QUAD CITIES UNITS 1 & 2 INDIVIDUAL PLANT EXAMINATION
TECHNICAL EVALUATION REPORT
(BACK-END)

**TECHNICAL EVALUATION REPORT OF THE QUAD CITIES
INDIVIDUAL PLANT EXAMINATION BACK-END SUBMITTAL**

REVISED FINAL REPORT

**R. Vijaykumar and M. Khatib-Rahbar
Energy Research, Inc.
P.O. Box 2034
Rockville, Maryland 20847-2034**

Figure 1

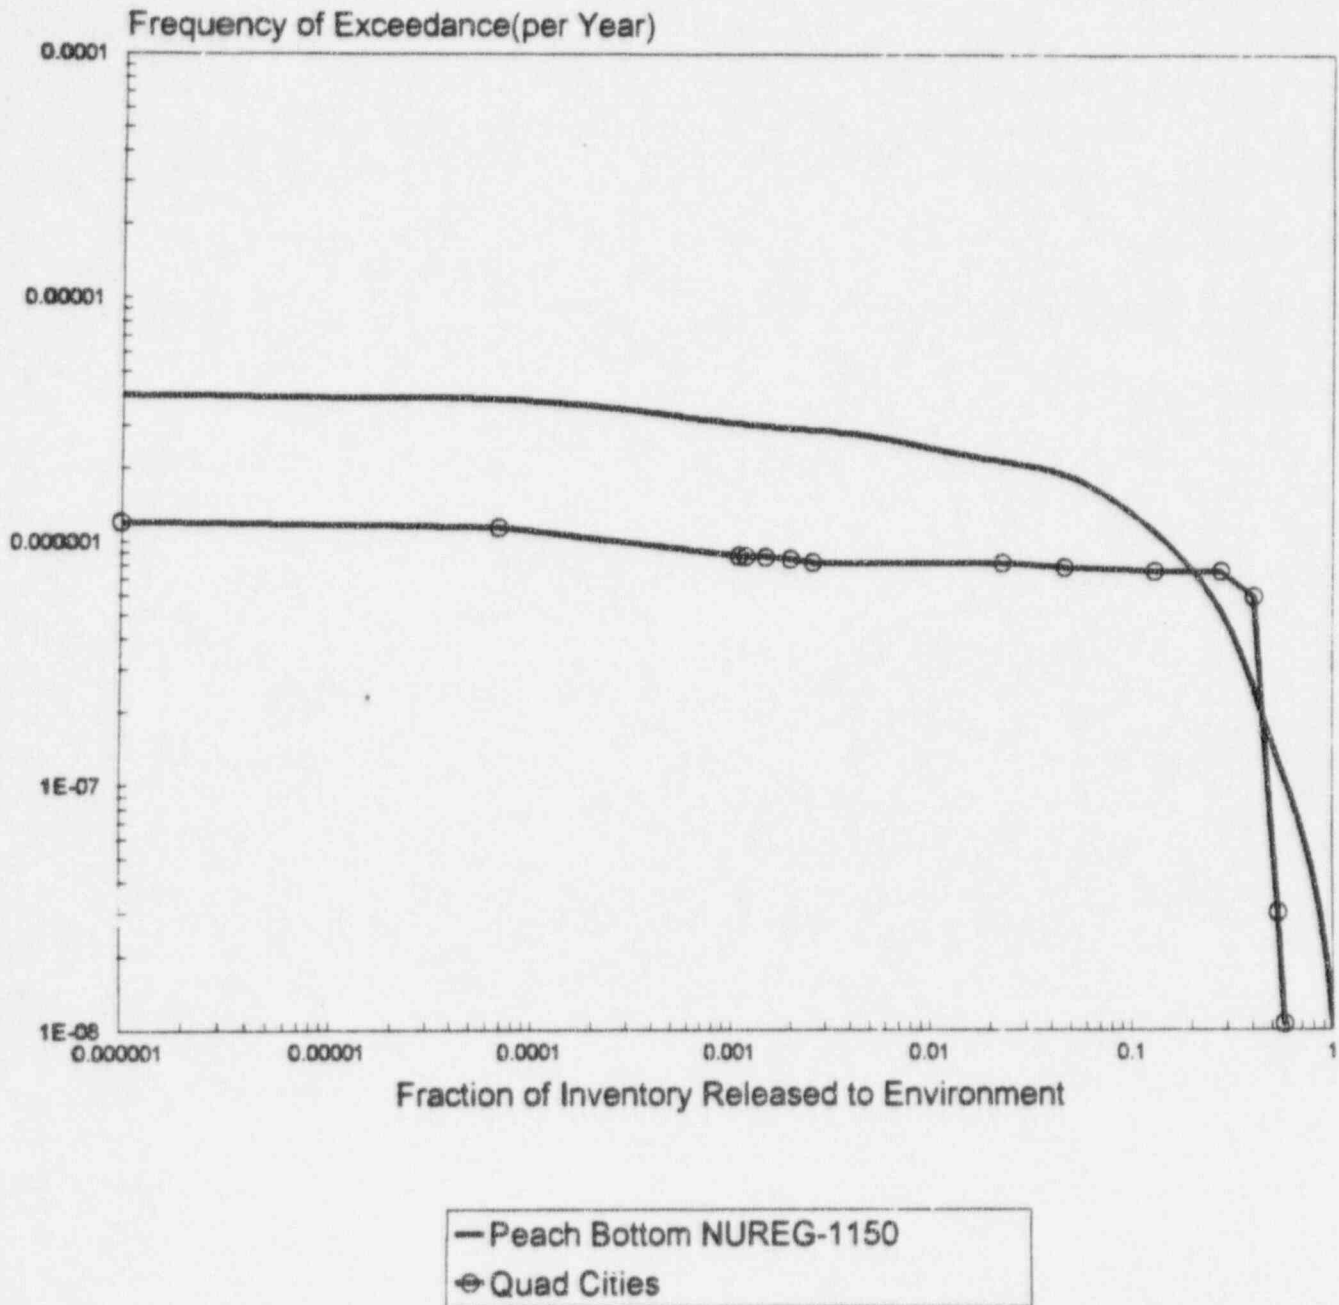
Figure 1 shows a comparison of the frequency of cumulative exceedance of CsI plotted as a function of the fraction of inventory released to the environment, as obtained from the results of the Quad Cities IPE submittal. The figure also shows a comparison of releases with the Peach Bottom NUREG-1150 analyses [11], and results from the Pilgrim IPE. The results show that there is a qualitative similarity between the Peach Bottom releases and the releases calculated by the IPE. However, one important difference is to be noted: the reported releases in the Quad Cities IPE submittal are cumulative releases at a time period of 48 hours. As such, a large component of the releases should be due to revaporization of fission products. In contrast, for Peach Bottom, a large fraction of the CsI releases are associated with liner melt-through at vessel breach (early containment failure).
